Dossier de la OHI N° S3/8151/S-100

**CARTA CIRCULAR 03/2025**  
**10 de enero del 2025**

**APROBACIÓN DE PUBLICACIONES DE LA OHI**  
**ESPECIFICACIONES DE PRODUCTO BASADAS EN LA S-100**  
**FASE 1 – S-101, S-102, S-104, S-111, S-129**

**MEMBER STATES' RESPONSES TO IHO CL 39/2024 AND COMMENTS  
FROM THE WORKING GROUP and PROJECT TEAM CHAIRS, IHO SECRETARIAT**

Figure 4-10 – Dataset loading – scenario 4

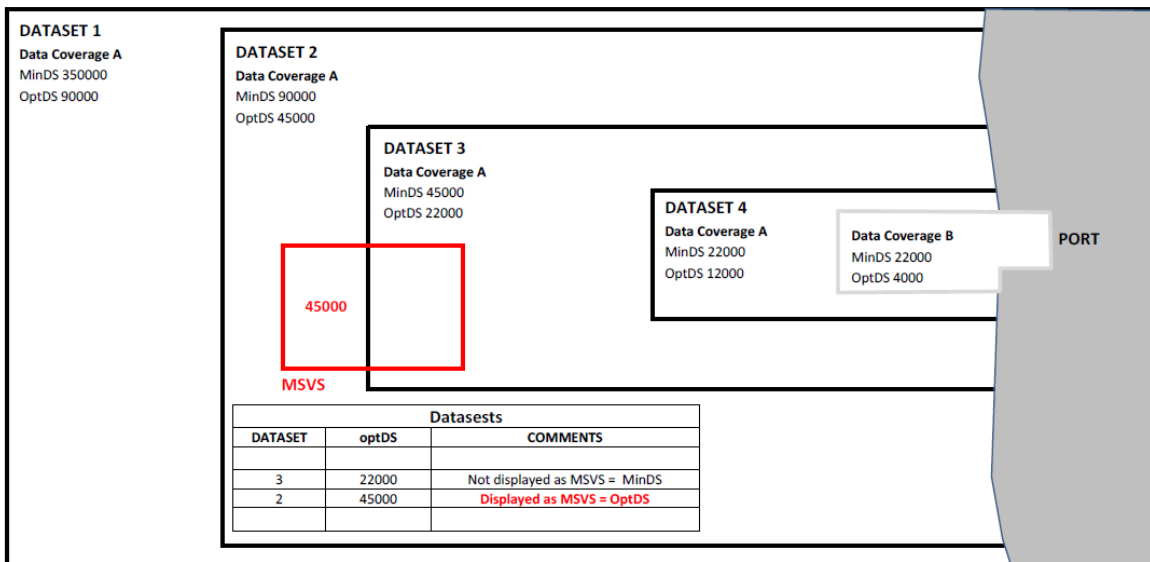
- 3) Product Specification - Add the attached Diagram to the end of Section 4.7.2 as a new Figure 4.10 and amend 2nd paragraph to read 'Figures 4-7 to 4-10 below are ...'

Please note that all other Figures in the PS will have to increase their number by one.

These proposed changes have been agreed for correction (point 1) and clarification (points 2 and 3) as they enhance the guidance already included. The proposed new Figure 4-10 for the S-101 Main document has been included as Figure 4-9 as this is a better fit within the order of the Figures 4-7 to 4-10 in regard to Mariners' Selected Viewing Scale (MSVS). The changes have been applied for the final operational Edition 2.0.0 of S-101.
